February 26, 2010

**Subject: Additional CDP Materials for the Los Osos Wastewater Project**

## Willow Creek Impacts

Figure 2 – Wetlands and Riparian Resources, 1949

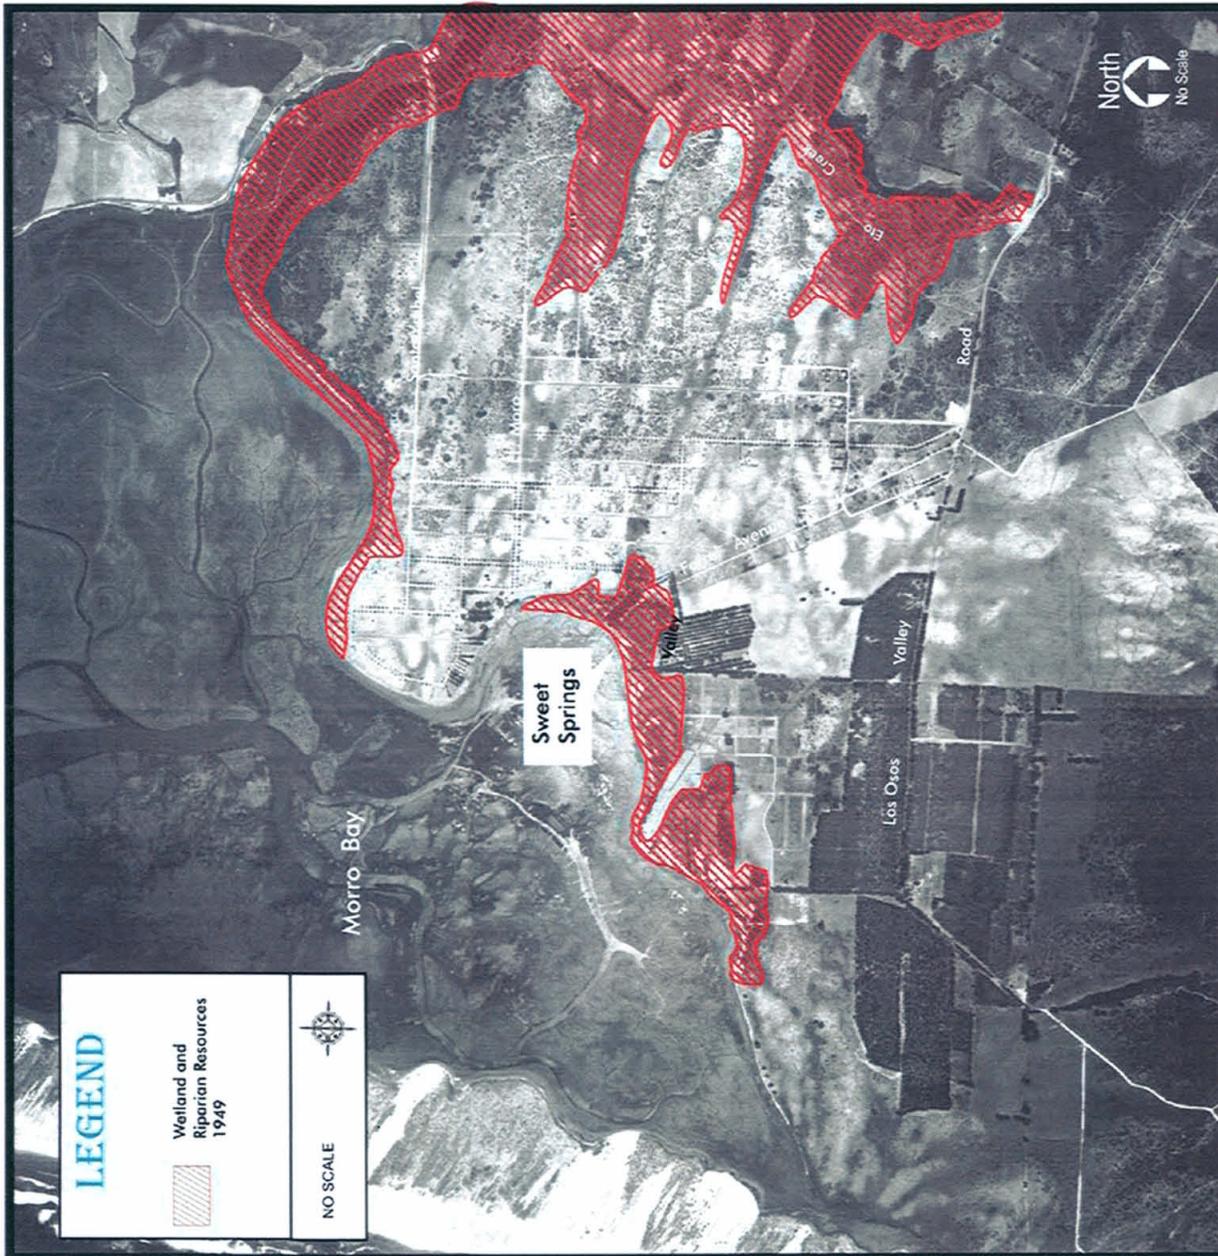
Willow Creek. The contention is that the project results in an unaddressed and unmitigated 400 afy reduction in flow to Willow Creek to the detriment of creek. We understand that the Bayridge leach field would be used to put back 33 afy as part of the project, and that the County apparently found that this 33 afy would be an equal offset to existing septic flows, but we would like a clearer explanation as to why the County found this to be the case, and how project flows will affect Willow Creek resources. Please provide an analysis with supporting documentation (again, new product and/or direction to information).

The comparison of aerial photographs from pre-development conditions is also a useful tool for predicting wetlands and riparian impacts. The attached figures show a comparison of pre-development (1949) and current conditions. The extent of wetland and riparian areas were much greater in pre-development conditions and demonstrate that the naturally occurring high groundwater levels in the perched aquifer are sufficient to support the existing habitat.

The Hydrogeological Impacts Study in the project EIR concludes that, while flow rates may be reduced, drainage will still occur in the Willow Creek area and that seasonal runoff and shallow groundwater are anticipated to provide sufficient water for use by the riparian vegetation established well before the Los Osos community was developed.
